# CITY PLANNING COMMISSION

- APPLICATION:**
- A. Special Permit to add drive-up window service to an existing 2,400+ sq. ft. 70 seat Dairy Queen restaurant on 0.33+ developed acres in the General Commercial (C-2) zone.
  - B. Lot line adjustment to merge 3 lots totaling 0.33+ acres in the C-2 zone.

**LOCATION:** 480 and 496 El Camino Avenue

**PROPOSAL:** The applicant is requesting the necessary entitlements to add a drive-up window to an existing Dairy Queen and abandon alley to allow access.

ELEVATIONS

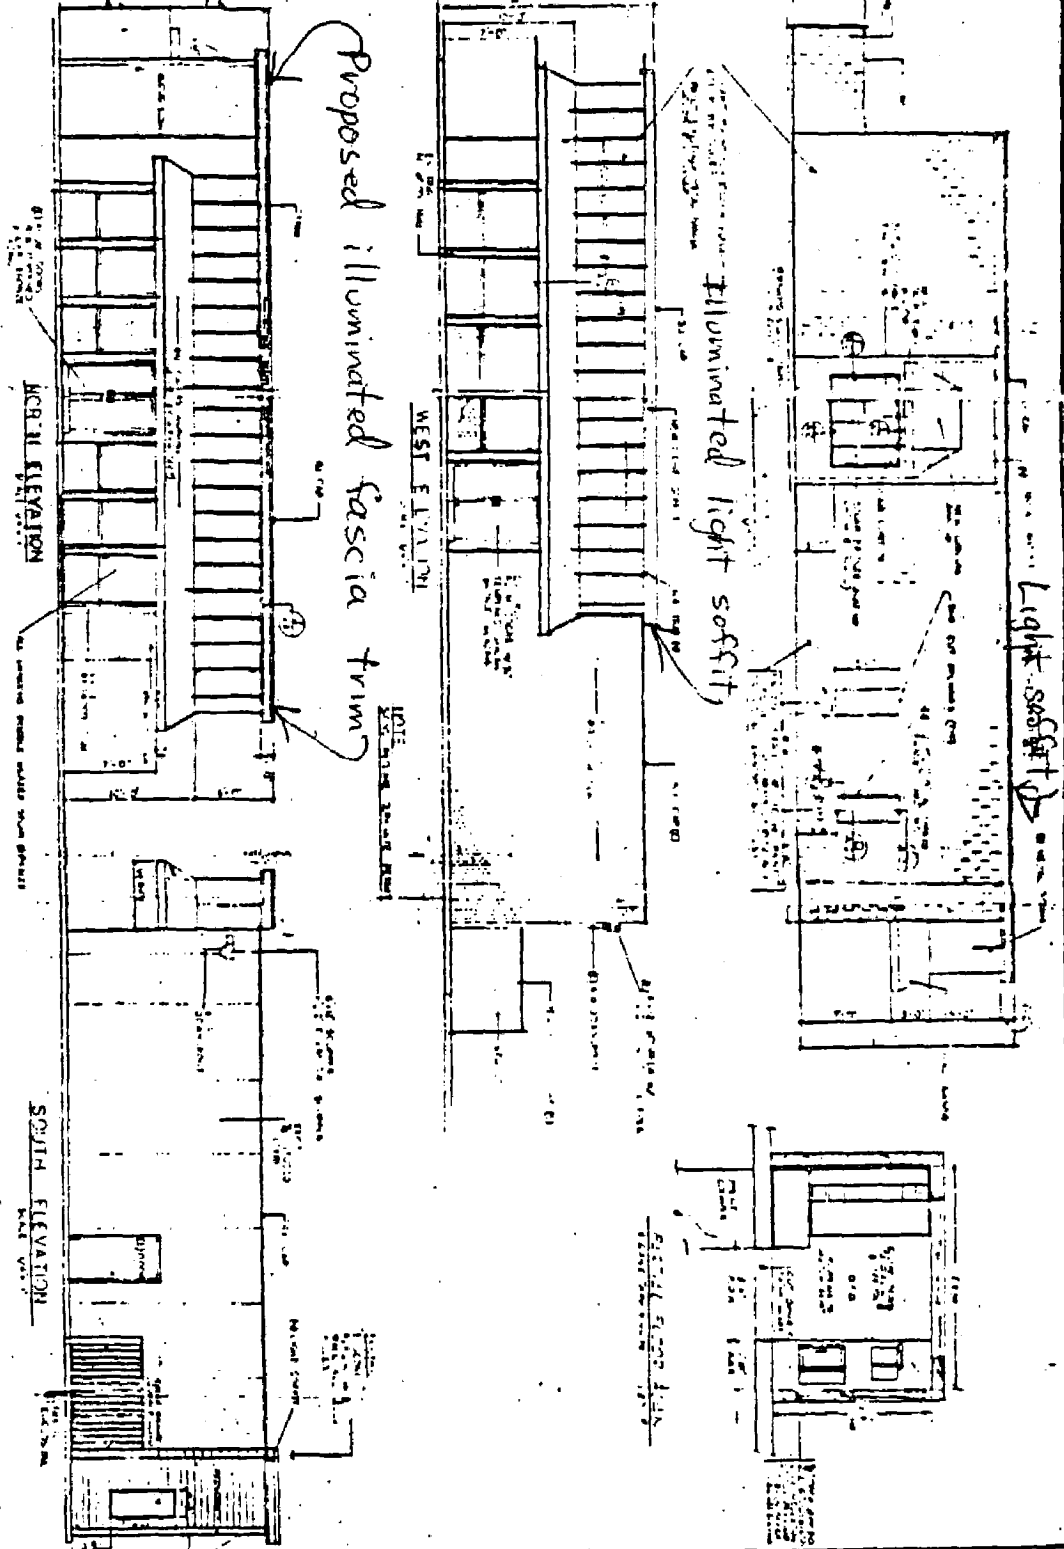
The applicant's elevations propose to modify the approved elevations in 1985. The addition of a canvas awning is proposed along the north and west elevations. Staff does not support locating an awning into the front building setback along El Camino Avenue. No color of the awning is proposed. Staff does not support the decorative awning since the building already projects close enough to property lines. No colors are indicated for either the awning or canopy. Staff does not support the structure or possible incompatible colors such as bright red or orange.

The applicant proposes an illuminated soffit along the top roof line on the east, north and west elevations. The soffit lighting outlines the building and is not allowed according to the City Sign Ordinance. Additionally, the lighting will reflect offsite onto residentially zoned or used property thereby creating a nuisance. Staff recommends the soffit lighting be eliminated from the elevations.

The east elevation proposes to have two saw cut windows and the drive-up window added. Otherwise, the wall remains stark and uninteresting. Staff has recommended a five foot wide landscape strip adjacent to the east elevation with shrubbery which will break up the lower portion of the wall. Staff recommends that a decorative trim element compatible with the north and west elevations be continued around to the east elevation along the top half of the wall area. This revised elevation shall be reviewed and approved by the City Design Review Coordinator prior to submittal for building permits.

19. The well shall be capped to City/County Health Department requirements.
20. Detailed elevations shall be revised to delete the canvas awning and soffit lighting. Elevations for the east view shall have a decorative trim element carried over from the west and north elevations. Elevation revisions are to be reviewed by Planning Director and approved prior to issuance of building permits.
